City of Albuquerque

RE: SAN MATEO BUSINESS PARK LOT 30-A (B-18/D6)
(5201 Venice NE)
ENGINEERS CERTIFICATION FOR CERTIFICATE OF OCCUPANCY
ENGINEERS STAMP DATED 10/30/2000
ENGINEERS CERTIFICATION DATED 9/3/2002

Drainage and
Grading Plan

C-1

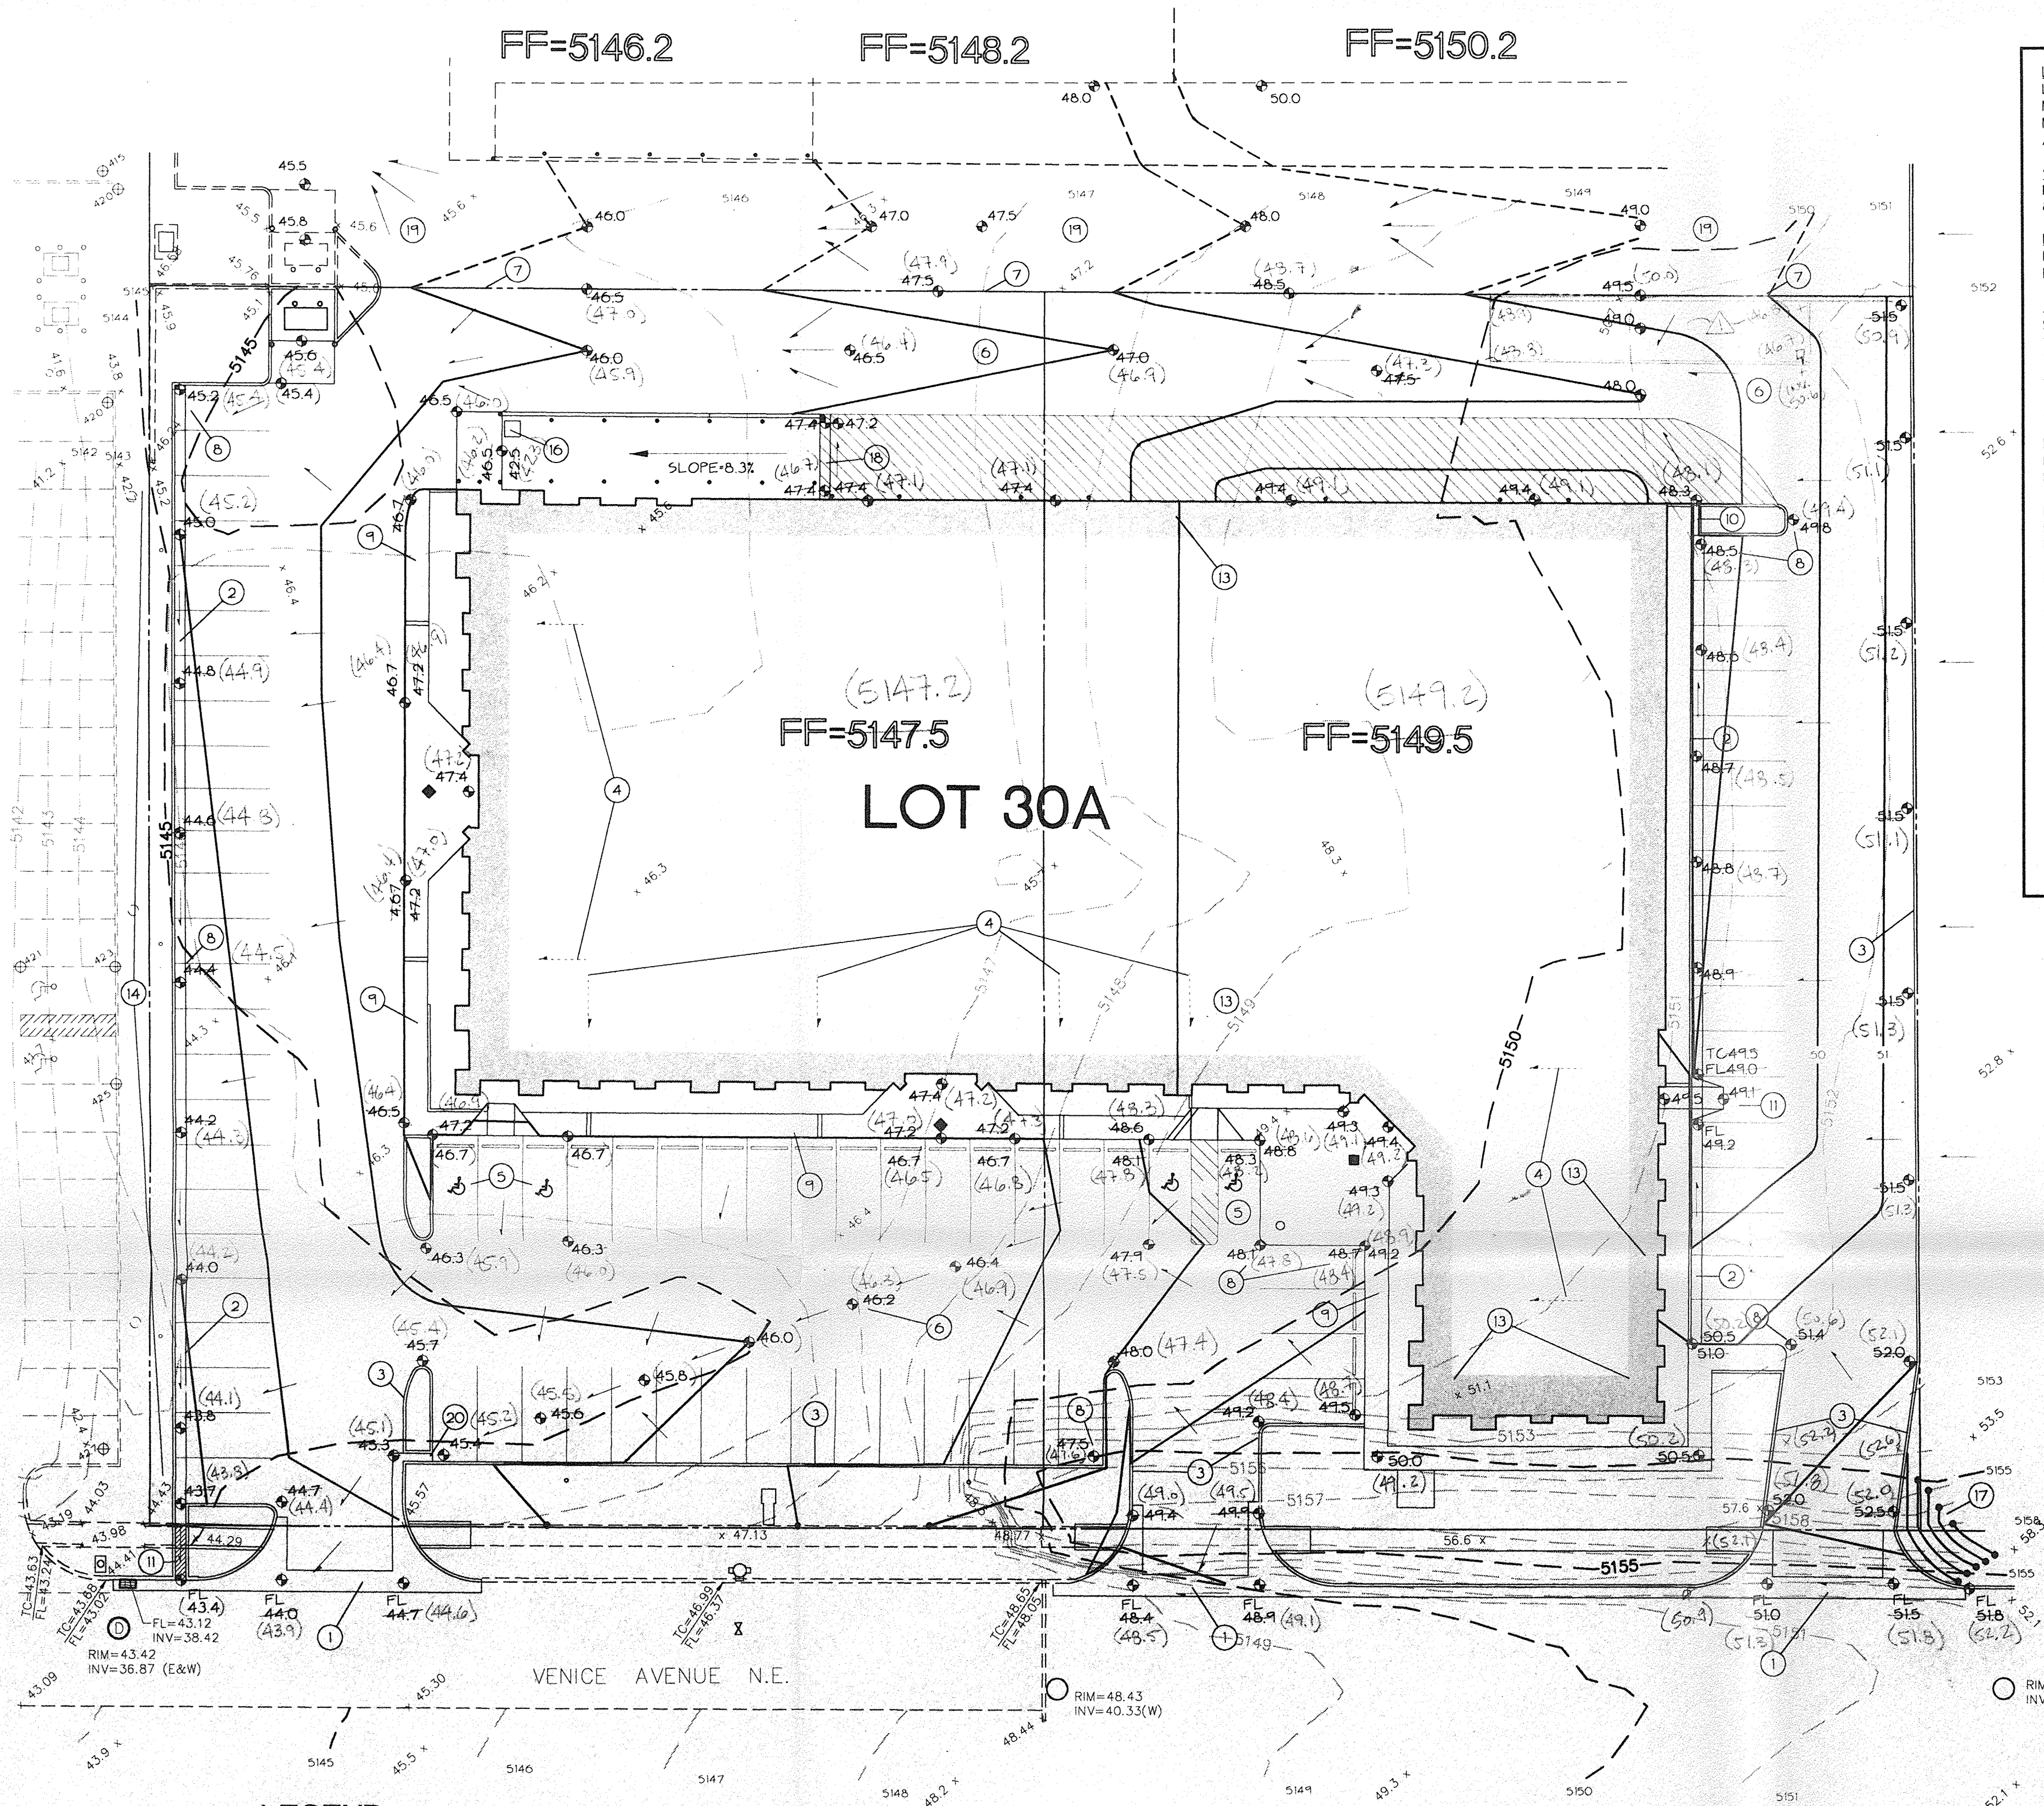
SAN MATEO BUSINESS PARK - PHASE II AREAS OF MODIFICATION BETWEEN APPROVED DRAINAGE GRADING PLAN AND ACTUAL AS-BUILT

Do not with sump pump added this area. OKAY

Based upon the information provided in your Engineers Certification submittal dated 9/6/2002, and based on the approved SO19 by the Storm Drainage Maintenance inspector, the above referenced site is approved for Permanent Certificate of Occupancy.
